# Groundwater Transfer Review Summary Form

Transfer/PA # T- 13757

Application: T-13757

Applicant Name: Pendleton Land LLC

Figure 1. Well location map

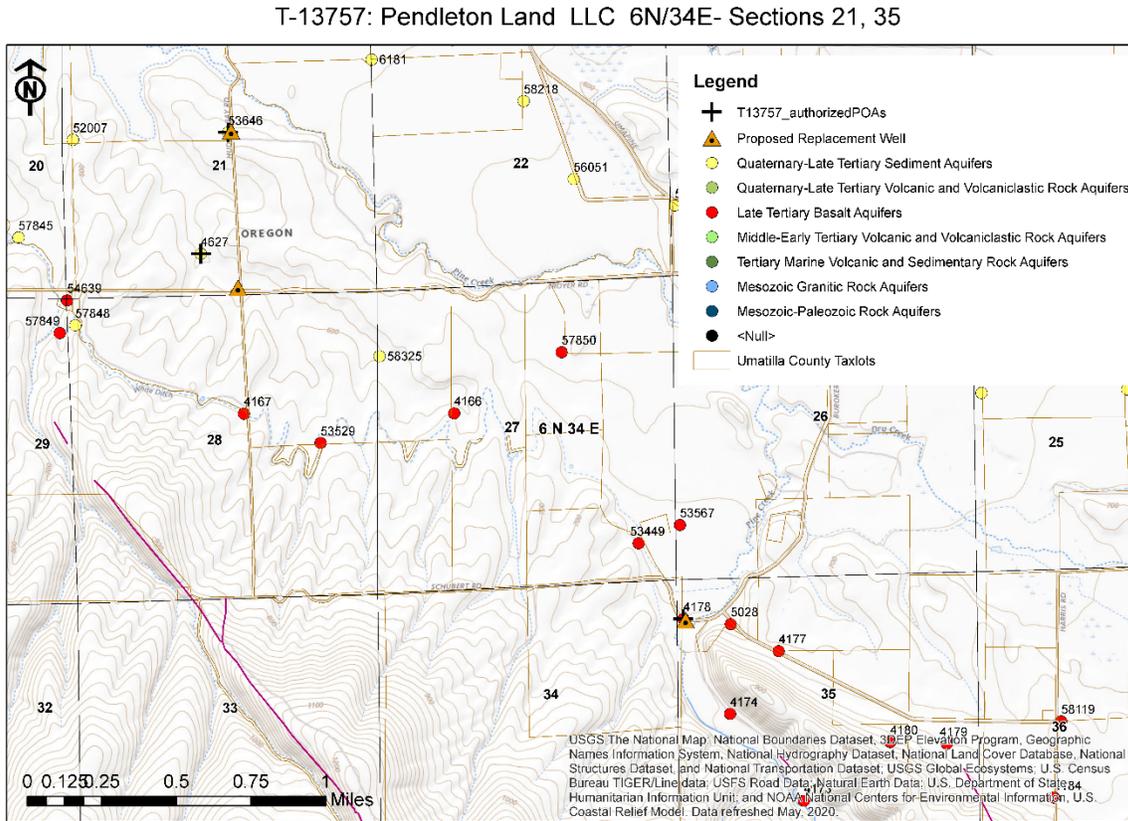
Yes  No Comments: The replacements for UMAT 4178 and UMAT 53646 are less than 100 feet from the current POAs. This change is not expected to measurably change interference with other fully penetrating, reasonably efficient wells. UMAT 4627's replacement is located at a greater distance from other wells in the same aquifer, so well-to-well interference is not expected to increase.

Yes  No Comments: See Table 2. New POA locations are less than 100' from current pumping locations for UMAT 53646 and UMAT 4178 replacements. The replacement for UMAT 4627 is located 1000 feet from the current location, but both locations are approximately 2800 feet from Pine Creek. The change in interference with surface water is expected to be largest at UMAT 53646 because it is the POA located closest to a creek. The new POA will be 50 feet closer to Pine creek.

Figure 2. Hydrograph of nearby basalt wells and UMAT 4178

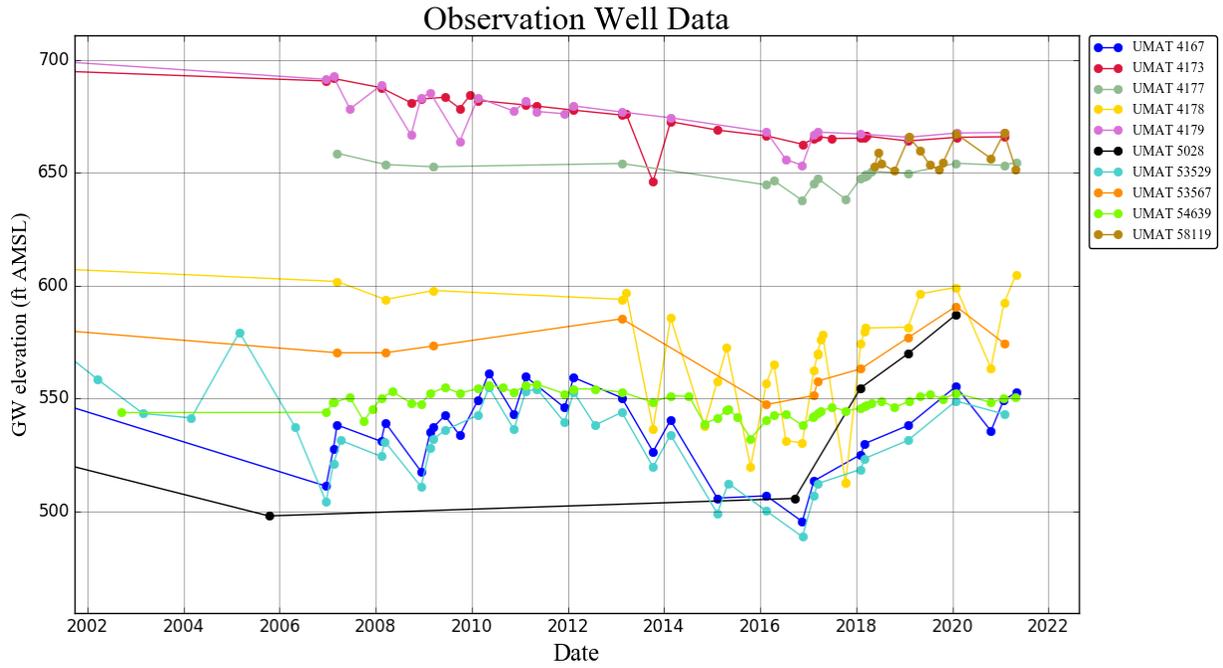
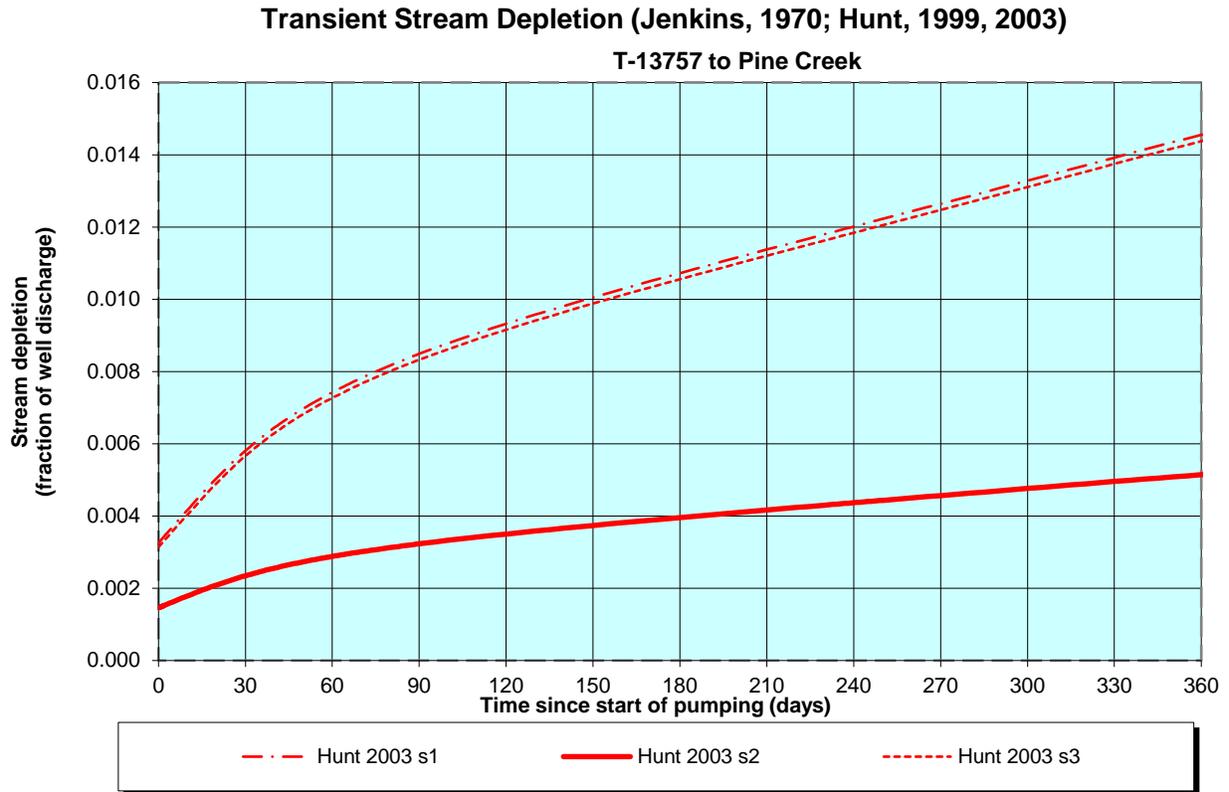
The water level at UMAT 4178 increases on the order of 50 feet in elevation when there is water in Pine Creek, which is located within 20 feet of this well. As shown in Figure 2, other nearby basalt wells show a total seasonal range of 20 feet between annual highs and lows (see UMAT 4179, UMAT 58119, UMAT 4167, UMAT 53529). The large increase in water level elevation at UMAT 4178 and the presence of gravel below the bottom of the casing indicates there is an efficient connection between this well and both a sedimentary and a basalt aquifer.

Because it develops at least 2 aquifers, UMAT 4178 will need to be abandoned and replaced by a basalt well that meets current well construction standards. 50% of the water right rate and annual volume associated with UMAT 4178 is transferrable to the new basalt point of appropriation.

The basalt well drilled to replace UMAT 4178 shall be open to a single aquifer in the Columbia River Basalt Group and shall meet applicable well construction standards (OAR 690-200 and OAR 690-210). The open interval may be approved by the Department if the applicant can demonstrate to the satisfaction of the Department that each well is only open to a single aquifer. Following well completion, the well shall be thoroughly developed to remove cuttings and drilling fluids. Substantial evidence of a single aquifer completion may be collected by video log, downhole flowmeter, water chemistry and temperature, or other downhole geophysical methods approved by the Department. These methods shall characterize the basalt rock and assess whether water is moving in the borehole. Any discernable movement of water within the well bore when the well is not being pumped shall be assumed as evidence of the presence of multiple aquifers in the open interval.
